Technical Bulletin / Safety Alert

Unique ID No : DES2018-TBSA-02 **Rev: 0**

Subject : Thermal Sensor Valves (optional alternative)

Applicable to : Diesel Engine Systems currently complying to: MDR 090376 DES
Typically installed in VLI Driftrunner & Brumby Vehicles

Figure 1
Thermal Sensor Valve (optional alternative)

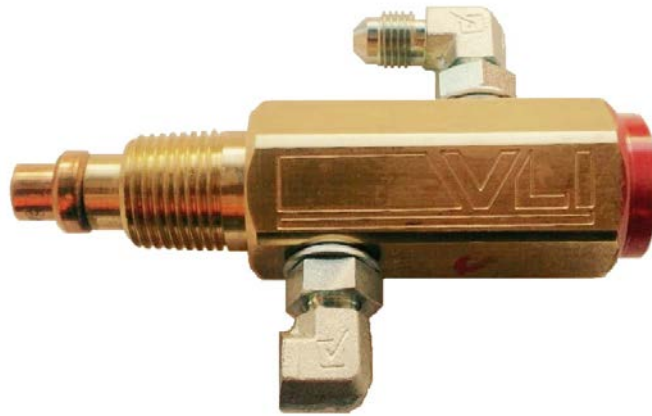
As a result of the review, VLI have developed an optional of an alternative Thermal Sensor Valve that we believe reduces the risk of incorrect installation.

The optional Thermal Sensor Valve is supplied with the fittings for the inlet & exhaust ports installed (the exhaust port fitting has had the hose connection thread removed to reduce the likely hood of connecting to the incorrect port).

Thermal Sensor Valve Temperature	Current Part Number	Part Number of Optional Alternative
100°C	9-04160116	9-1416006-004
82°C	5-04107301	9-1416006-003
75°C	5-04167401	9-1416006-002
